Post Public Consultation Report

Dundrum Bus Layover Scheme

National Transport Authority &
Dún Laoghaire-Rathdown County Council

April 2026

Figure 2.1: Bus Gate Preliminary Design

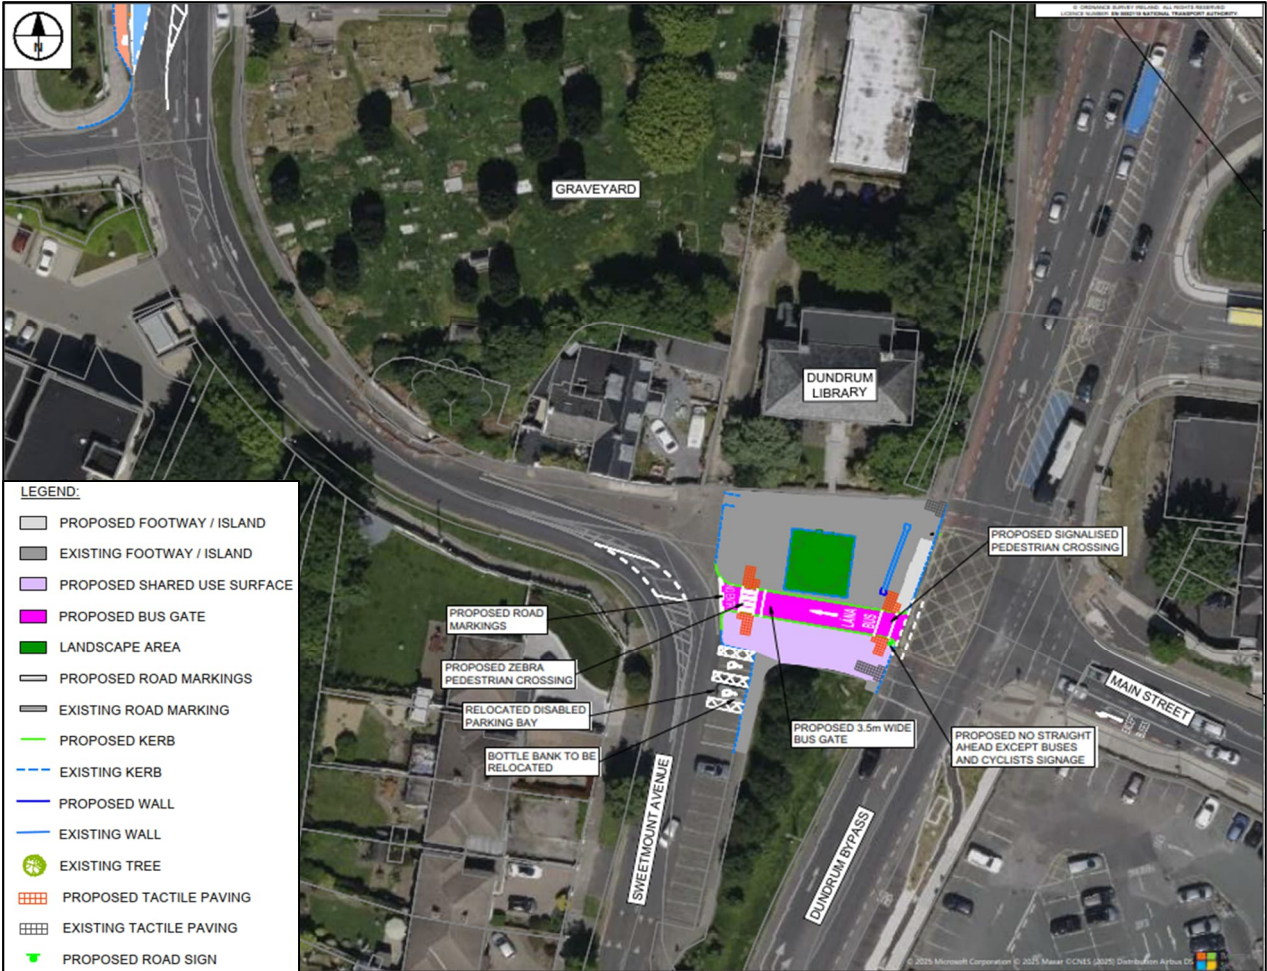
<p>2: Bus Gate – Safety, Local Traffic & Civic Space Concerns</p>	<p>A substantial number of submissions focused on the proposed bus gate between Main Street and Sweetmount Avenue, raising concerns about its impact on local safety, traffic patterns, and civic space.</p>	<p>372</p>	<p>The proposed bus gate will facilitate the movement of buses from Dundrum Main Street to Sweetmount Avenue and Churchtown Road Upper, which is a critical to the functioning of the proposed bus layover spaces.</p> <p>The proposal of a bus gate at this location was included in the 2023 DLAP and many of the concerns relating to the Bus Gate have been previously</p>

Key Issue	Description	Count	Response to Issues Raised
	<p>Respondents worried that the bus gate could divert traffic onto residential streets, increasing risks for pedestrians and cyclists, particularly children and elderly residents.</p> <p>Many highlighted the potential loss of civic space at the junction, noting its importance as a community gathering point and the negative impact on the village's character.</p> <p>Concerns also included the adequacy of enforcement, the clarity of signage, and the potential for confusion among drivers unfamiliar with the new layout.</p>		<p>addressed in the <i>Chief Executive's Report on Draft Plan Consultation August 2023</i>. Section 3.4.5 of the report states:</p> <p><i>“the executive notes that the ABTA study has not identified any adverse impact on traffic movements along Sweetmount Avenue, Churchtown Rd Upper or Dundrum bypass, as a result of any potential bus gate between the bypass and Churchtown Rd Upper. Having regard to the NTA's BusConnects programme, the executive has identified that bus movements through the area would be relatively low frequency at approximately 1 bus every 6 mins during peak travel times. reducing to 1 bus every 10 mins during off peak times. In terms of impact on residential amenities, it should be highlighted that bus services, including double deckers are a core element of public transport throughout Dublin and their operation along urban / suburban roads is well established. The low frequencies indicated above together with progressively quieter, cleaner bus models being rolled out under BusConnects will ensure minimal impact on residential areas.</i></p> <p><i>There are no proposals to make Churchtown Rd Upper one way and also no evidence to suggest that increased littering/pollution will occur in the area or that children or the elderly would be impeded. It is also not considered that any severance of Sweetmount Ave from Dundrum will occur as a result of bus gate option as all existing pedestrian and traffic routes are being maintained with additional pedestrian and cycle routes proposed to address existing severance caused by the bypass. Any bus gate would be signal controlled and only available to authorised buses.</i></p> <p><i>The Executive is satisfied that local heritage elements will not be adversely impacted, and that the layout can be implemented with minimal impact on car parking, cycle parking and the existing open nature of the area to the front of the library.”</i></p> <p>The upgrade to the traffic signals at Main Street and Dundrum bypass will be developed and agreed with DLRCC departments including Intelligent Traffic Systems (ITS). The proposed new bus gate / upgrade to the signals will not have an impact upon traffic capacity, as it can be accommodated within the existing phasing arrangement at the junction.</p>

Key Issue	Description	Count	Response to Issues Raised
			<p>In relation to pedestrian safety in the vicinity of the proposed bus gate, the design ensures safe and convenient movement of pedestrians and cyclists through the provision of a signalised pedestrian crossing at the start of the bus gate, the provision of a signposted shared area to the south of the bus gate and an update of the tactiles arrangements through this area (including the Dundrum Bypass / Dundrum Main Street Junction) to match current best practise and guidelines.</p> <p>Further response on Pedestrian Safety and Impacts on Mobility-Impaired Residents & Elderly Access is given below in row 4 & 15.</p>
<p>3: Suitability of Churchtown Road Upper for Bus Layover (Traffic, Environmental & Residential Impacts)</p>	<p>Numerous respondents questioned the appropriateness of Churchtown Road Upper as a location for bus layover facilities. Concerns centred on the potential for increased traffic congestion, noise, and air pollution in a predominantly residential area.</p> <p>Submissions cited the proximity to homes, schools, and community amenities, raising fears about reduced quality of life, safety risks, and adverse environmental impacts. Many suggested that the area’s existing infrastructure was ill-suited to accommodate additional bus movements and layover activities.</p>	<p>311</p>	<p>The provision of bus layover spaces on Churchtown Road is essential to relocate the existing layover spaces from Waldemar Terrace. The designs have been developed to comply with the relevant design standards at national and local level. Furthermore, Road Safety Audits has been completed for the scheme to ensure any safety issues are identified and addressed.</p> <p>As noted above in the response to Key Issue 1: Traffic Congestion & Junction Capacity, the Chief Executive has highlighted <i>“that bus services, including double deckers are a core element of public transport throughout Dublin and their operation along urban / suburban roads is well established. The low frequencies indicated above together with progressively quieter, cleaner bus models being rolled out under BusConnects will ensure minimal impact on residential areas”</i></p> <p>The scheme will assist to promote walking and cycling infrastructure in Dundrum, to promote modal shift to encourage more people to travel via sustainable modes.</p>

Figure 2.3: Churchtown Road Upper (Northbound) Preliminary Design

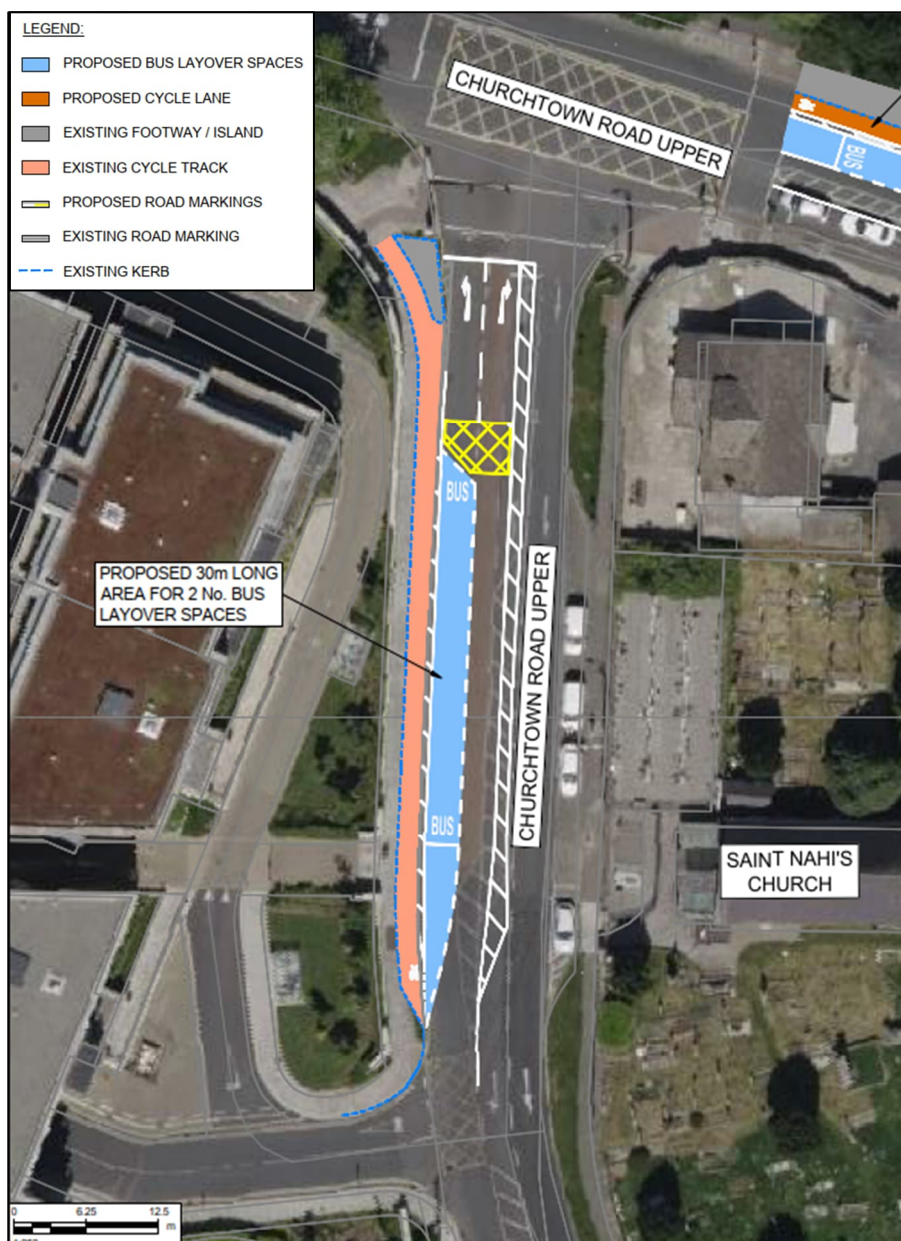
12: Loss of Parking (St Nahi’s Church, Fernbank & Churchtown Road Upper)	The potential reduction or relocation of parking spaces, especially near St Nahi’s Church, Fernbank, and Churchtown Road Upper, was a major concern for many respondents. Submissions emphasized the importance of parking for churchgoers, elderly residents, people with disabilities, and local businesses. Many feared that loss of parking would hinder access to key destinations, reduce footfall, and create additional challenges for those with limited mobility.	197	The proposals will not reduce the existing designated car parking on the eastern side of Churchtown Road Upper adjacent to St Naithi’s Church. It is noted that informal parking occurs on the existing cycle lane during events at the Church. It is envisaged that the proposed scheme will discourage parking on the northbound cycle lane along Churchtown Road Upper to ensure the cycle track is protected and to accommodate the bus layover spaces.
